TFL Pre-Application Discussions

Proposed new mixed used development, Pinner Road, Northwood, London, HA6 1DD

TFL Pre-Application Discussions

May-July 2022

Proposed Ground Floor Plan

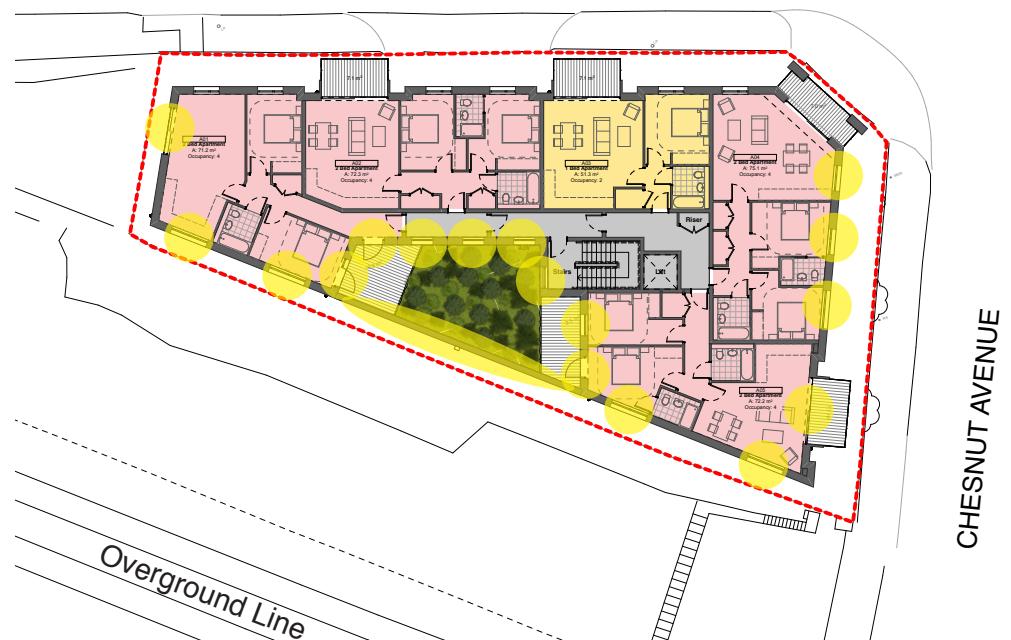
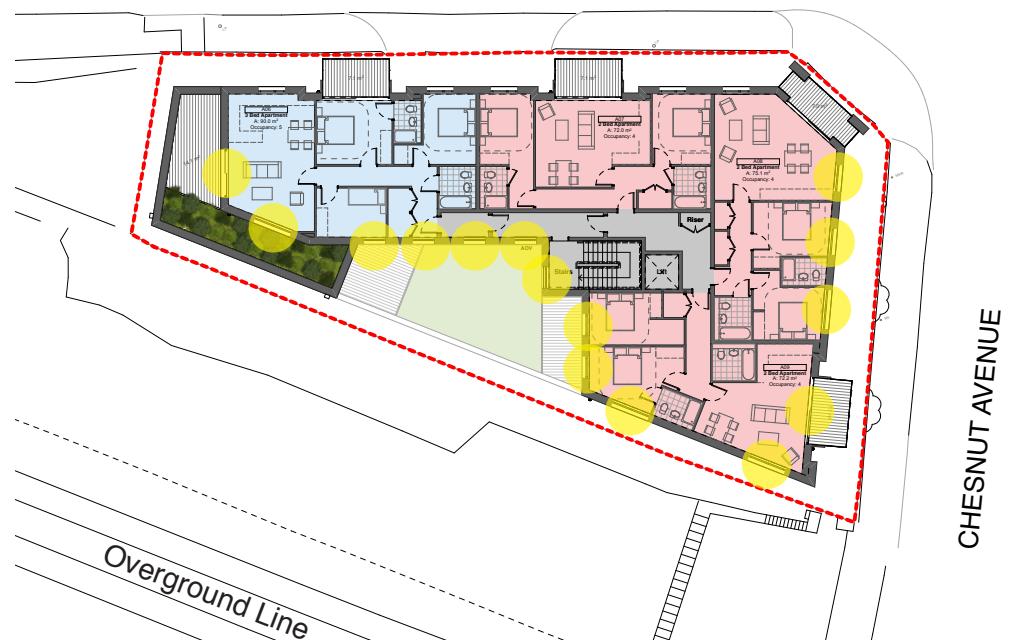
TFL Pre-Application Discussions - Reflective Surfaces

Whilst there is no specific guidance from TFL on the acceptable levels of reflectivity of surfaces at any given distance to the railway, consideration has been given to this concern raised by the LU engineer.

Much of the facade is proposed as brickwork with very little or no level of reflectivity. The stair core is proposed to be clad in metal rainscreen cladding (as can be seen on the proposed elevations) that will be powder coated in a matt or satiny finish without metallic pigments. There are however windows and balustrading proposed facing the railway and following initial discussion with the LU engineer, the design will incorporate anti-glare glazing which can provide as little as 1% reflectance. The proposed locations of the anti-glare glazing are shown on the plans adjacent (highlighted with yellow circles).

Proposed First Floor Plan

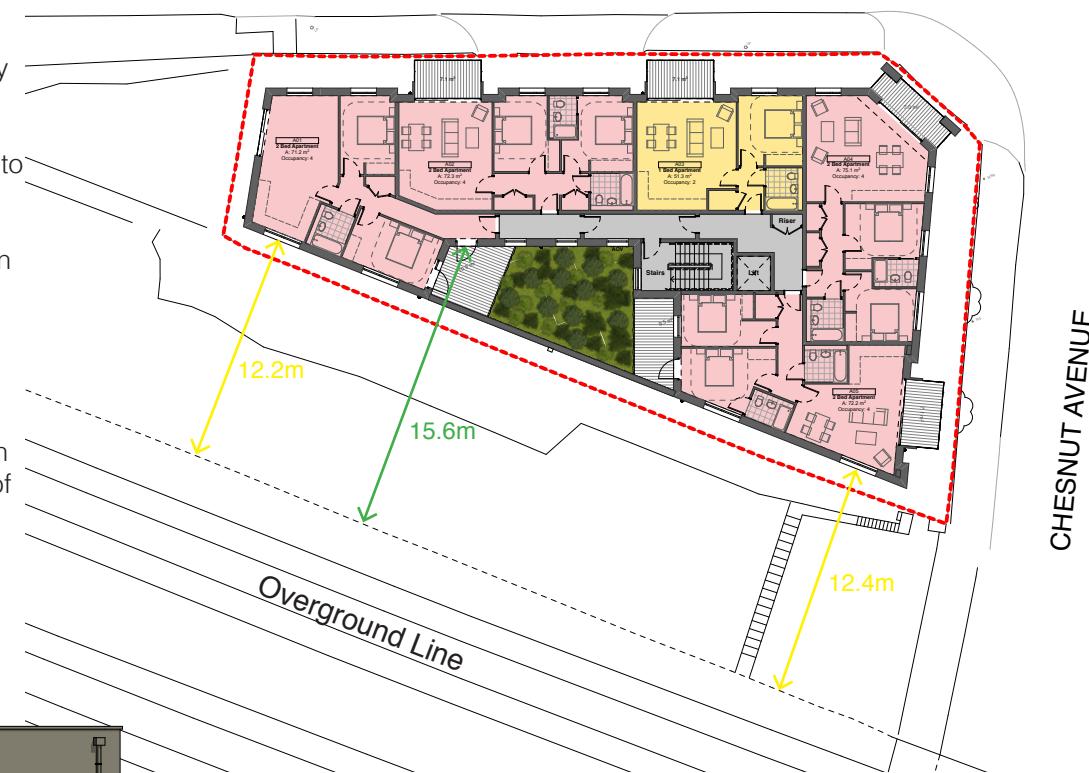
TFL Pre-Application Discussions - Proximity of Openable Windows

Whilst there is no specific guidance from TFL in regard to openable windows and their proximity to the railway, consideration has been given to this where windows are immediately overlooking the TFL boundary and any potential nuisances arising from fully openable windows in this location.

As seen in the adjacent first floor plan the distance from the top of railway embankment to the nearest window is approximately 12.2m.

Windows with restrictors (max 100mm opening) are proposed to the Southwest Elevation facing towards the railway (highlighted yellow on the below proposed southwest elevation) to limit the potential for rubbish being thrown onto the TFL access route adjacent the Southwest boundary.

Other openable windows facing in this direction are set further back from the TFL boundary looking over the first and second floor landscaped terraces (highlighted green on the below elevation), with the closest openable window being 14.3m away from top of railway embankment and the remainder tapering away further still.

Proposed First Floor Plan Extract

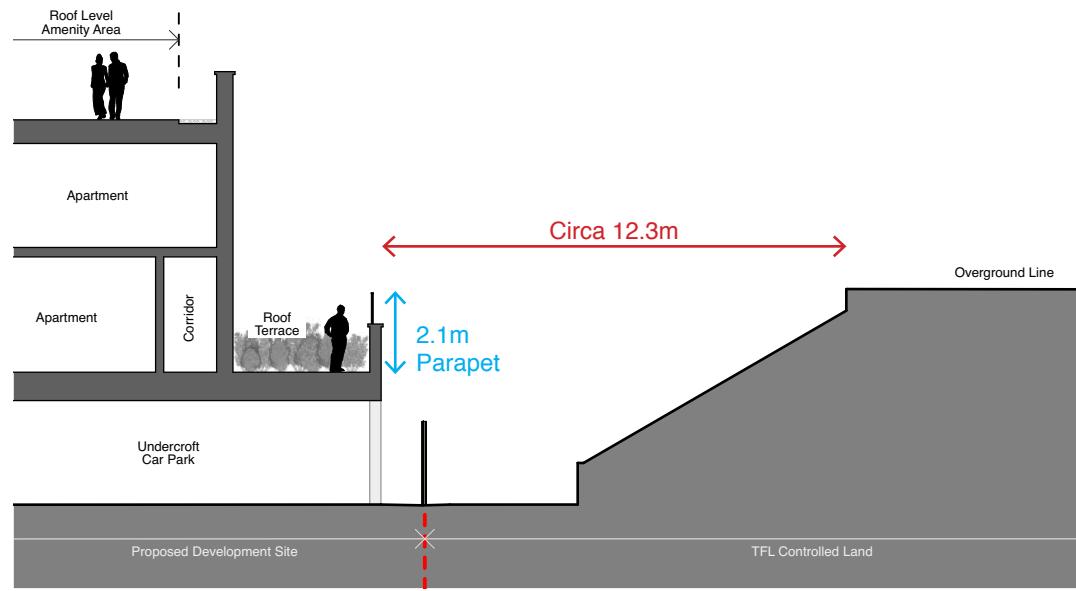
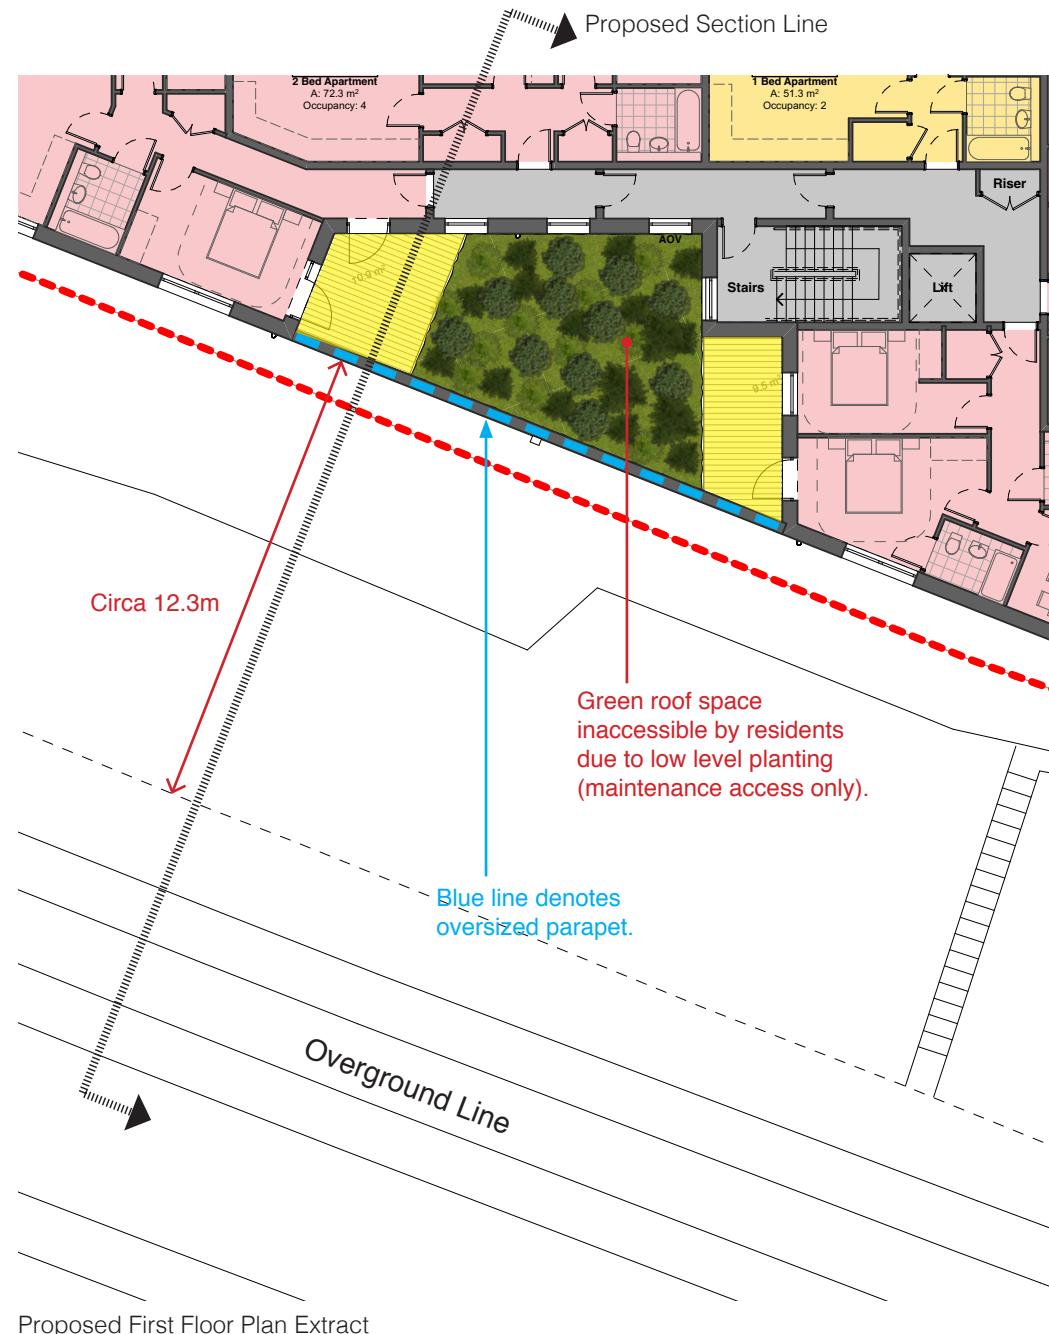
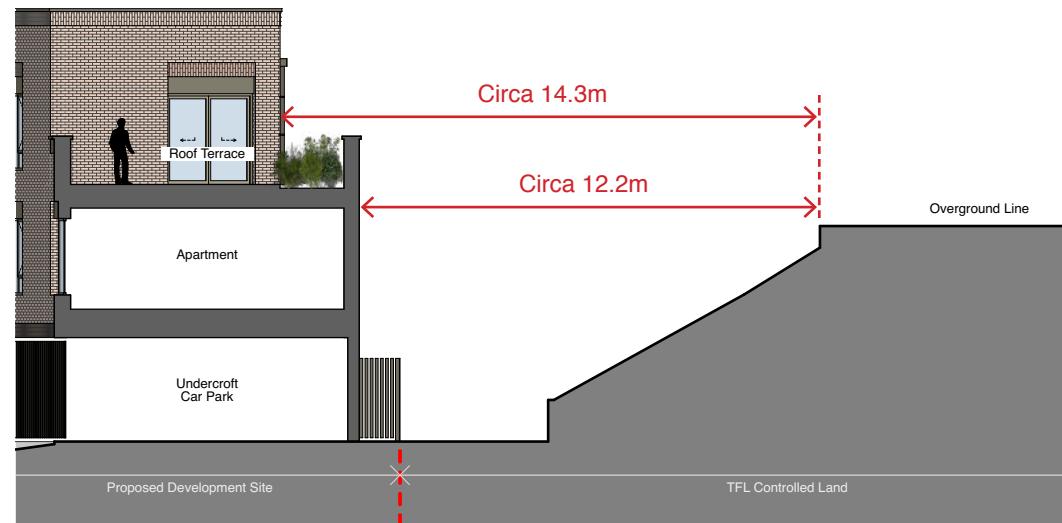
Whilst there is no specific guidance from TFL on the acceptable distances of balconies or roof terraces to the railway, consideration has been given to this concern raised by the LU engineer.

Roof terraces are proposed at first floor level to meet the requirements of the London Housing Design Guide and provide at least the minimum areas of private amenity space for the proposed dwellings. The small terraces at first floor level are facing into the development and do not face towards the railway (highlighted yellow on the adjacent plan), however they do flank the parapets on their shortest sides that face over TFL boundary and towards the railway. We are therefore proposing to provide larger than standard parapet heights to these terraces (see section below) consisting of part solid parapet wall with glazed balustrade above to create a solid barrier to the Southwest Elevation. The total height of the parapet and balustrade will be circa 2.1m high (equivalent to a tall boundary fence) and glazing to the balustrade will be anti-glare as described previously.

Furthermore it can be seen adjacent and below that there is considerable distance between these terraces and the top of the railway embankment which also resides at a higher level than the terrace.

Proposed Second Floor Plan Extract

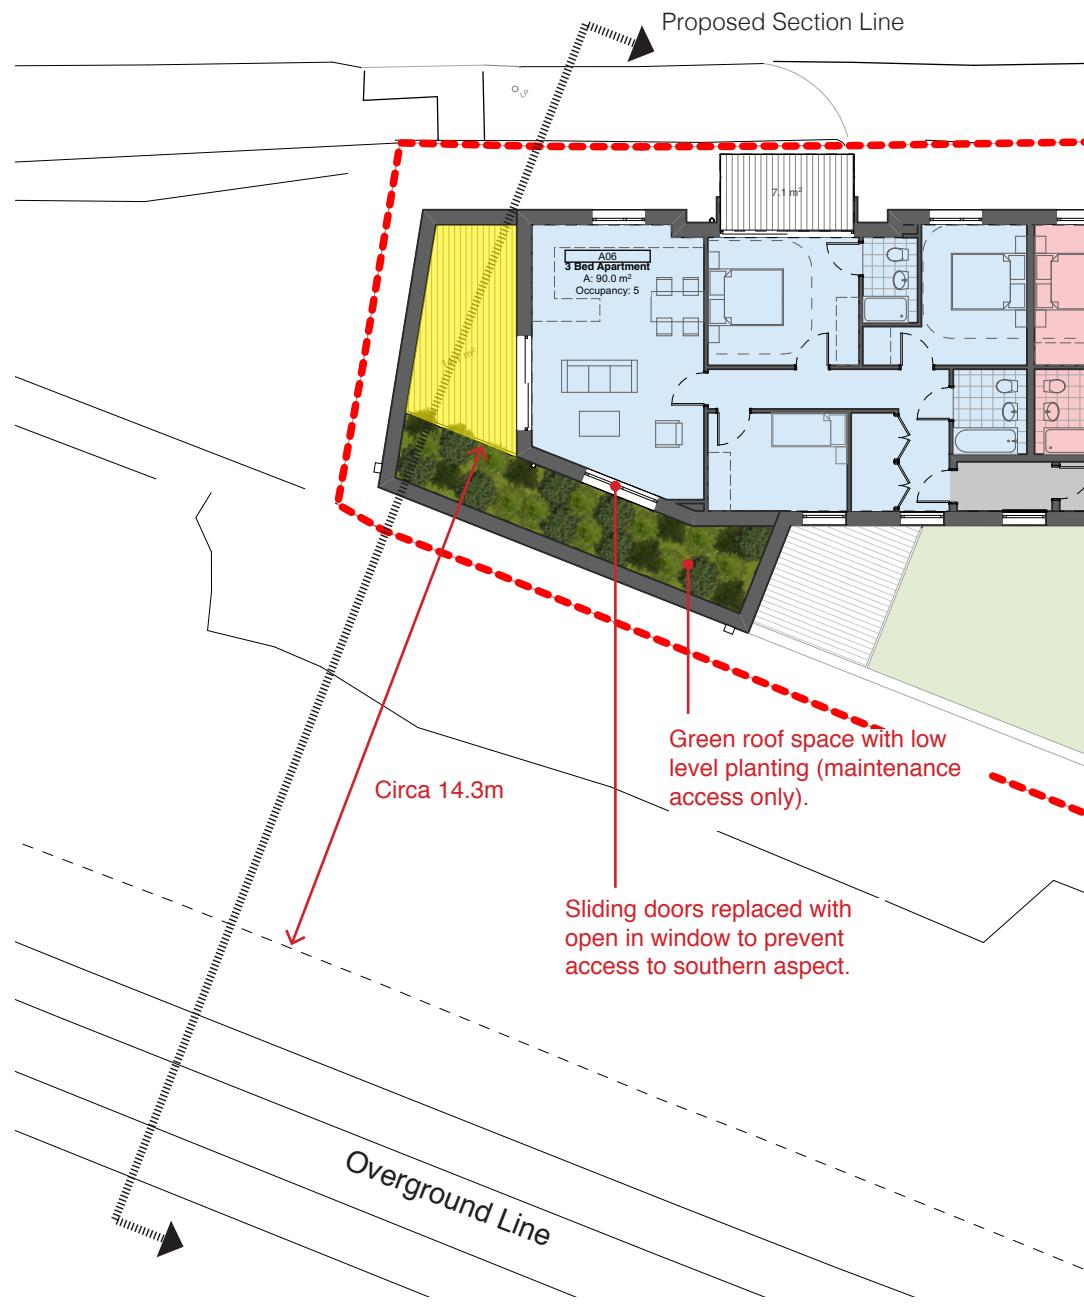
Second Floor Private Roof Terrace

A roof terrace is proposed at second floor level to meet the requirements of the London Housing Design Guide and provide at least the minimum area of private amenity space for the proposed dwelling. The terrace at second floor level (highlighted yellow on the adjacent plan) previously faced towards the railway (May 22 proposals). The design has developed allowing for a green roof space with low level planting to prevent residents from being able to access the roof space facing towards the railway, however intermittent maintenance will be required. Doors previously facing towards the railway and accessing the now removed southwest facing section of the terrace have been replaced with open in windows to allow for cleaning.

Furthermore it can be seen adjacent and below that there is considerable distance between this terraces and the top of the railway embankment.

Proposed Section A

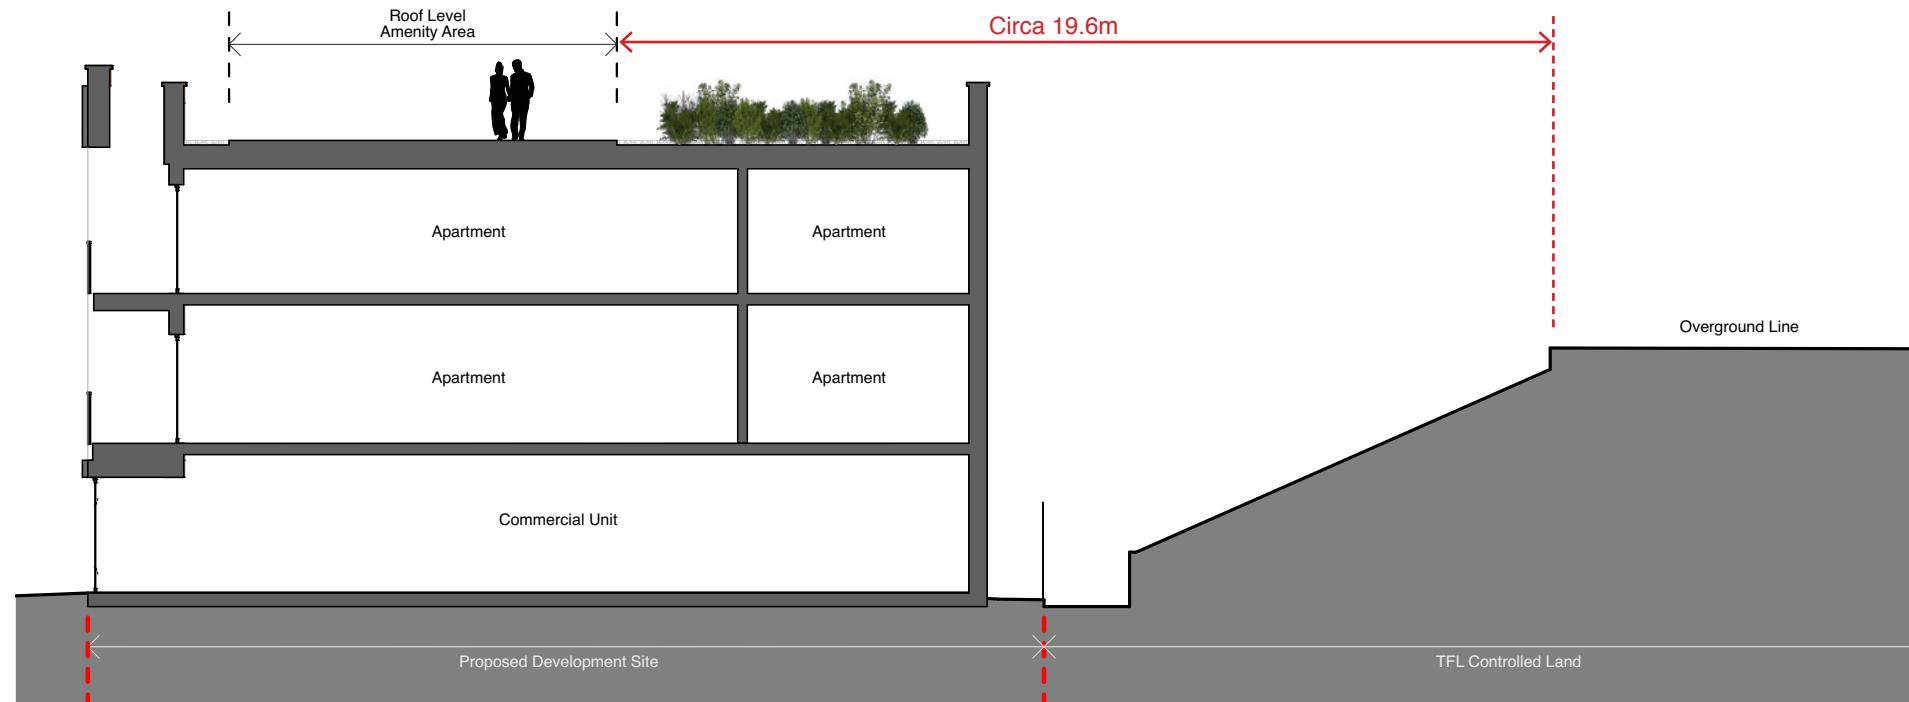
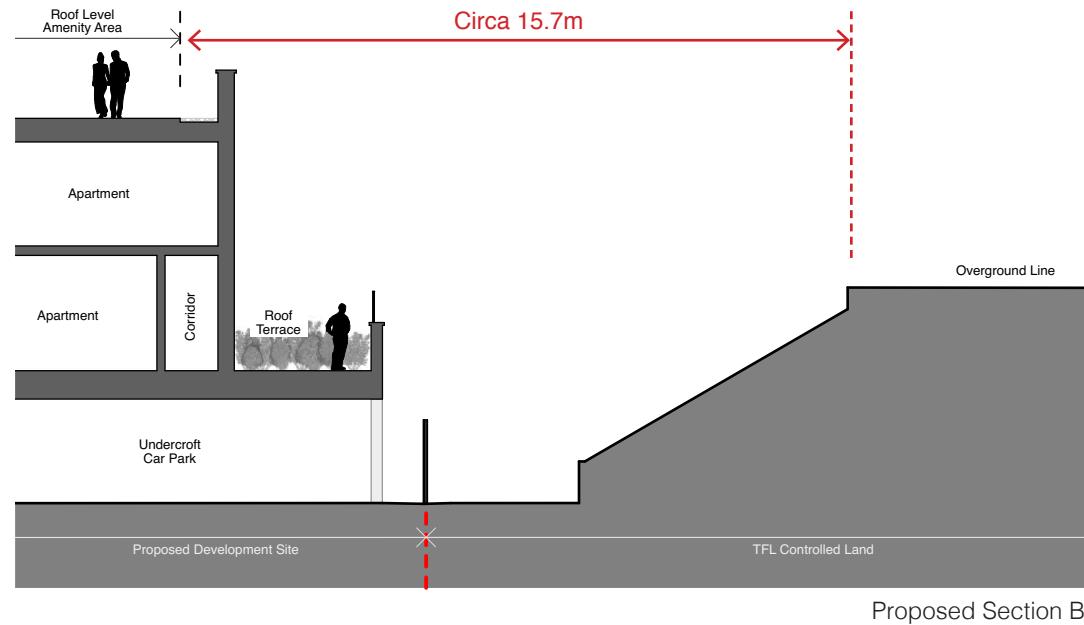
Third Floor/ Main Roof Amenity Space

An outdoor amenity area is proposed at roof level to meet the requirements of the London Housing Design Guide and provide at least the minimum area of shared amenity space for the residents of the development.

The amenity space (highlighted yellow on the roof plan on the next page) has been redesigned to maximise the distance between accessible parts of the roof space and the railway as can be seen in the sections below/ adjacent and roof plan on the next page.

A planted area has been added to the roof that will prevent residents from being able to access the parts of the roof immediately adjacent the TFL boundary. In addition a perimeter of deterrent paving surrounding the accessible parts of the roof terrace act as a deterrent in accessing the edges of the roof.
